NEW MEXICO
ENVIRONMENT DEPARTMENT

Hazardous Waste Bureau

August 6, 2010

RE: BULK FUELS FACILITY SPILL, SWMUS ST-106 AND SS-111
DIRECTIVE FOR CONDUCTING INTERIM MEASURES AND NOTICE OF DISAPPROVAL
INTERIM MEASURES WORK PLAN, JUNE 2010;
VADOSE ZONE WORK PLAN, JUNE 2010;
GROUNDWATER INVESTIGATION WORK PLAN, JUNE 2010
KIRTLAND AIR FORCE BASE, EPA ID# NM9570024423
HWB-KAFB-10-015, HWB-KAFB-10-016, HWB-KAFB-10-019

Figure 1. Soil Boring and
Soil-Vapor Monitoring Well Locations

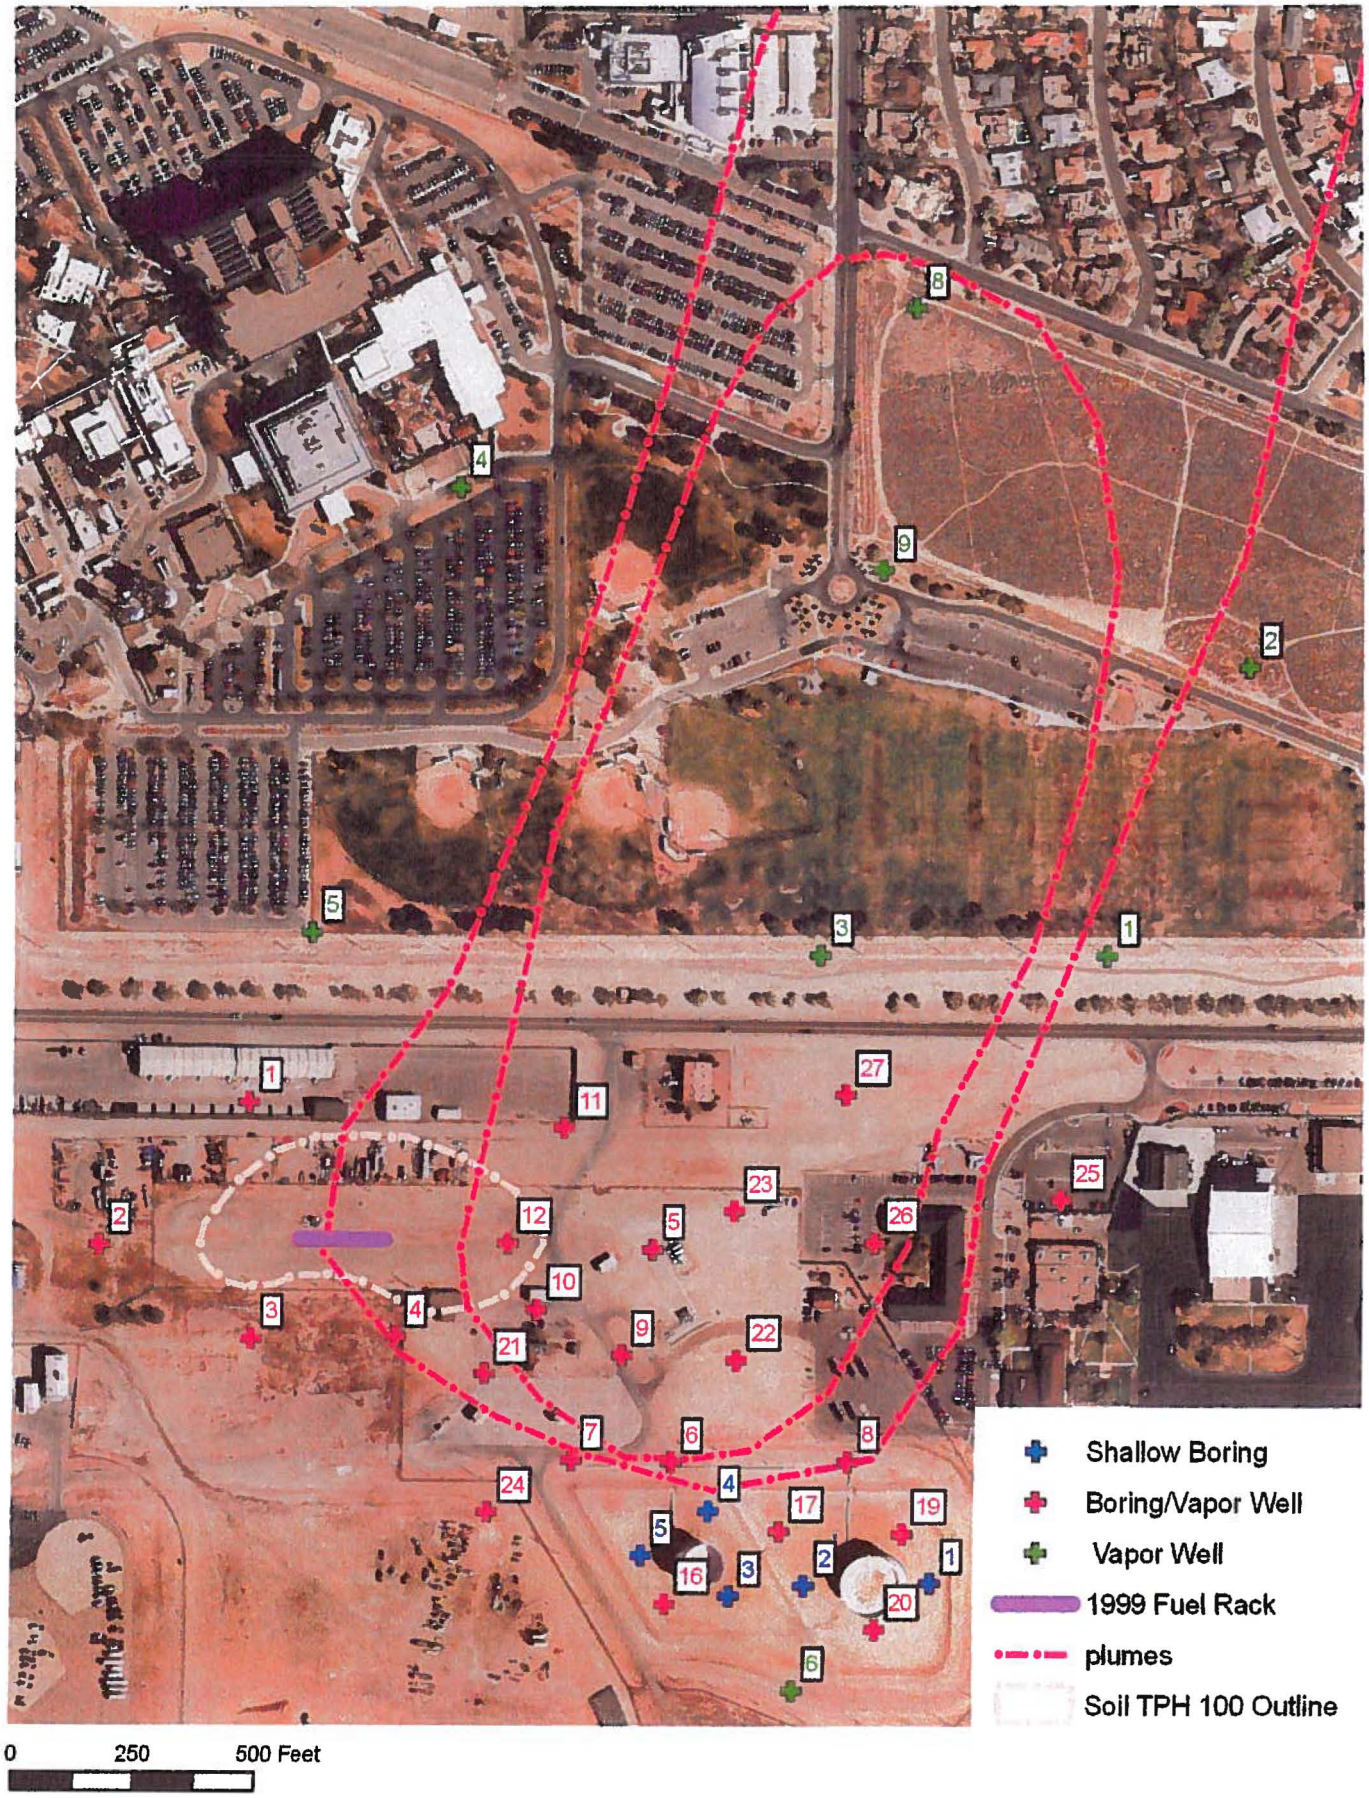
The Permittee shall complete the soil borings/soil-vapor wells at locations #16, 17, 19 and 20; and the soil vapor well at location #6 that are listed in Tables 1 and 2 of this letter, respectively, and shown on Figure 1 enclosed with this letter. The Permittee shall also complete shallow soil borings to a depth of at least 20 feet at locations #1 through 5, which are listed in Table 3 of this letter and shown also on Figure 1. Soil samples from the shallow borings shall be collected at depths of 0, 5, 10, 15, and 20 feet and shall be analyzed for TPH, VOCs, SVOCs, and lead.

The Permittee shall complete the deep soil borings/soil-vapor wells at locations #4, 6, 7, 8, and 24 that are listed in Table 1 of this letter and shown on Figure 1. The Permittee shall also complete shallow borings along the entire length of the pipeline between the tank farm and the Fuel Offloading Rack, regardless of whether the pipeline runs underground or on the surface. The borings shall be spaced at intervals not to exceed 25 feet and are to be located on both sides of the pipeline. Soil samples from the shallow borings shall be collected at depths of 0, 5, 10, 15, and 20 feet. The soil samples from deep and shallow borings shall be analyzed for TPH, VOCs, SVOCs, and lead. Depending on the results, NMED may require further investigation of this area, including more and deeper borings.

The Permittee did, however, propose an additional 3 deep soil sampling/vapor wells at locations further to the east. NMED agrees that these latter locations are necessary to properly characterize this area. Thus, to improve the understanding of the amount of fuel contamination in the vadose zone that must be remediated, the Permittee shall complete the soil borings/soil-vapor wells at locations #5, 9, 10, 21, 22, 23, 25, 26, and 27 listed in Table 1 and shown on Figure 1.

5. Far field area of Soil-Vapor plume – In its letter of April 2, 2010, NMED directed the Permittee to install six soil-vapor wells at locations north of the Fuel Offloading Rack and fuel percolation area to investigate the concentrations of hazardous constituents in soil gas that overlies groundwater in these areas. The Permittee shall complete the soil-vapor wells at locations #1, 2, 4, 3, 5, 6, 8, and 9; and the soil boring/soil-vapor well at location #24, that are listed in Tables 2 and 1, respectively, and shown on Figure 1.

The coordinates in Tables 1-3 are State Plane Coordinates in feet, NAD83. All boring/soil vapor well locations are also shown on Figure 1 enclosed with this letter.

Figure 2. Groundwater Monitoring Well Locations

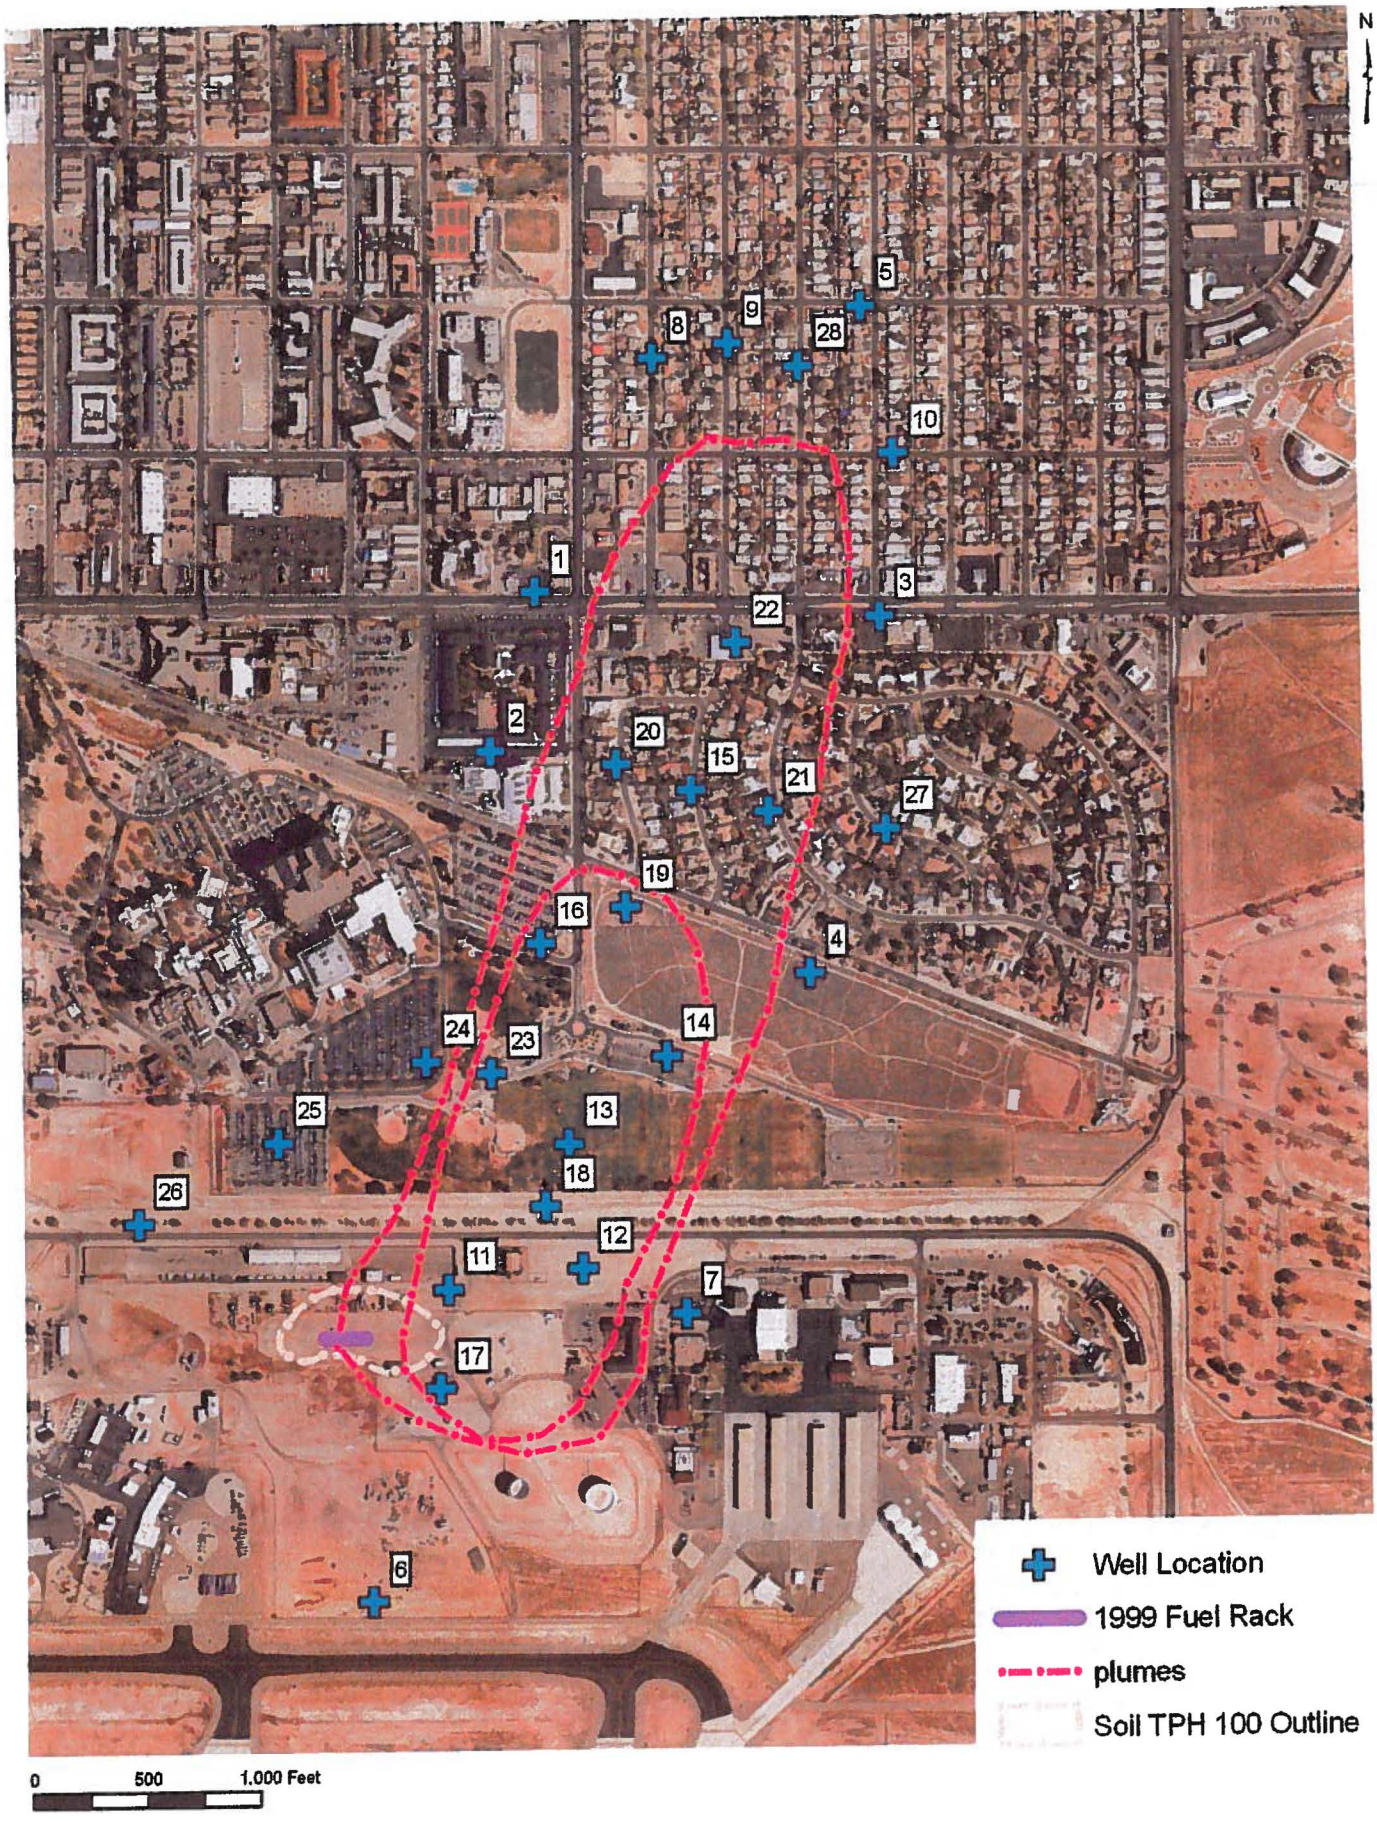
1. Background Water Quality - Only two upgradient wells have been installed that potentially may yield groundwater samples that are free from contamination. Both of these wells were only recently completed; none is screened appreciably below the water table to provide vertical characterization of water quality, geology, and hydrologic conditions. The Permittee must complete the background cluster/nested wells at location #6 listed in Table 4 of this letter and shown on Figure 2 (enclosed).

To achieve the objective of providing initial plume-core characterization, the Permittee shall install the groundwater monitoring wells at locations #11, 12, 13, 14, 15, 16, 17, 18, 19, 20, 21, 22, and 23 listed in Table 4 and shown on Figure 2.

To adequately provide initial plume-edge characterization, the Permittee shall install the groundwater monitoring wells at locations #1, 2, 3, 4, 5, 7, 8, 9, 10, 24, 25, 26, 27, and 28 that are listed in Table 4 and shown on Figure 2.

Coordinates in Table 4 are State Plane Coordinates in feet, NAD83. All of the locations listed in Table 4 are also shown on Figure 2 enclosed with this letter.

Figure 3 Existing Soil Boring, Soil-Vapor Monitoring Well and Cross-Section Locations

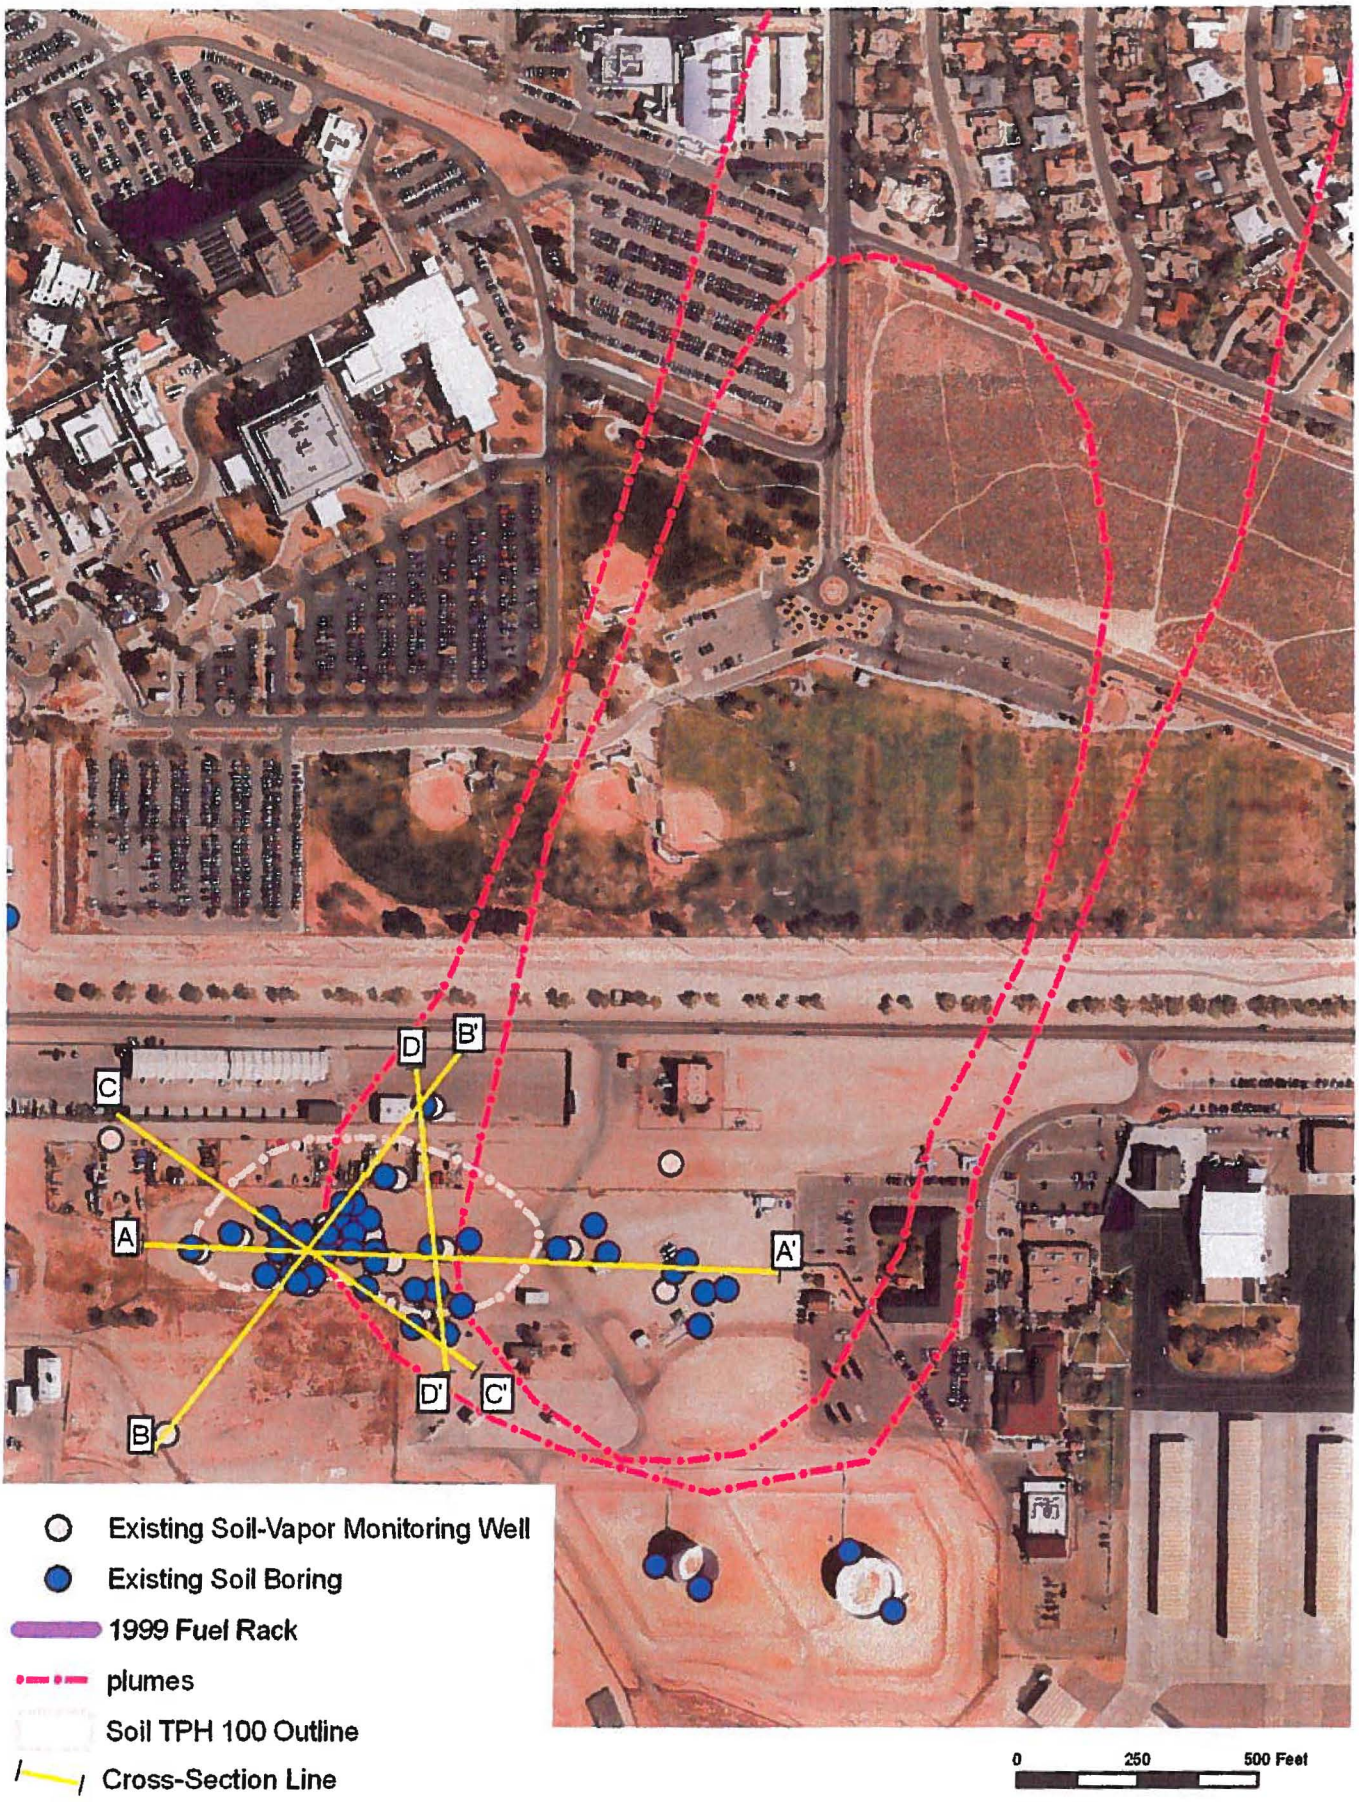
v. Cross-sections showing the geology of the site drawn to a horizontal scale of 1 inch equals 50 feet, a vertical scale of 1 inch = 50 feet, and along the orientations A-A', B-B', C-C', and D-D' as shown on Figure 3 enclosed with this letter.
vi. Cross-sections showing the geology of the site drawn to a horizontal scale of 1 inch equals 300 feet, a vertical scale of 1 inch = 50 feet, and along the orientations A-A', B-B', C-C', and D-D' as shown on Figure 4 enclosed with this letter.
vii. Cross-sections showing concentrations of major hazardous constituents in soil, drawn to a horizontal scale of 1 inch equals 50 feet, a vertical scale of 1 inch = 50 feet, and along the orientations A-A', B-B', C-C', and D-D' as shown on Figure 3 enclosed with this letter.
viii. Cross-sections showing concentrations of major hazardous constituents in soil vapor, drawn to a horizontal scale of 1 inch equals 50 feet, a vertical scale of 1 inch = 50 feet, and along the orientations A-A', B-B', C-C', and D-D' as shown on Figure 3 enclosed with this letter.

Figure 4. Existing Well and Cross-Section Locations

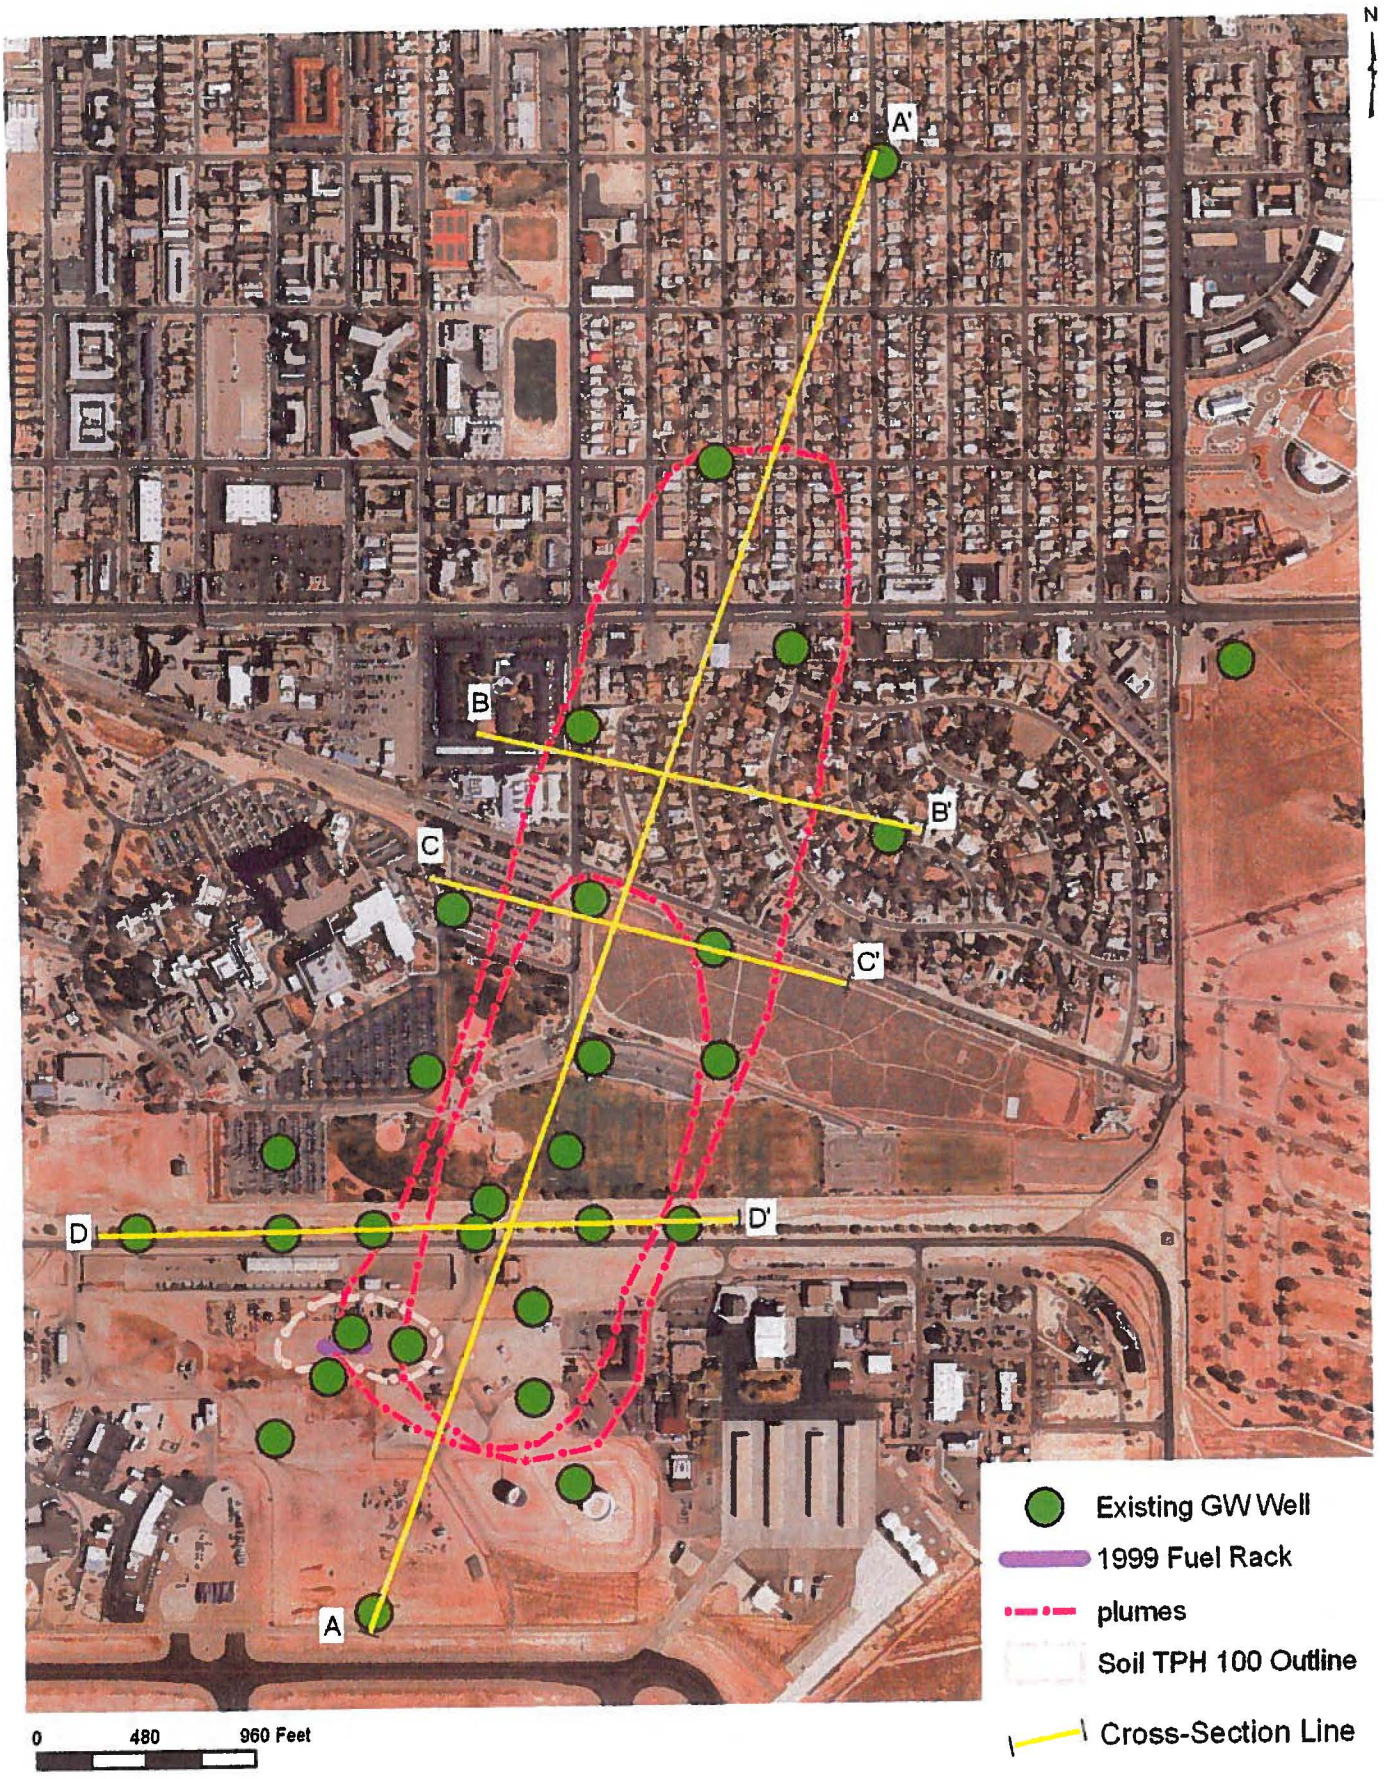
ix. Cross-sections showing concentrations of major hazardous constituents in groundwater, drawn to a horizontal scale of 1 inch equals 300 feet, a vertical scale of 1 inch = 50 feet, and along the orientations A-A', B-B', C-C', and D-D' as shown on Figure 4 enclosed with this letter.
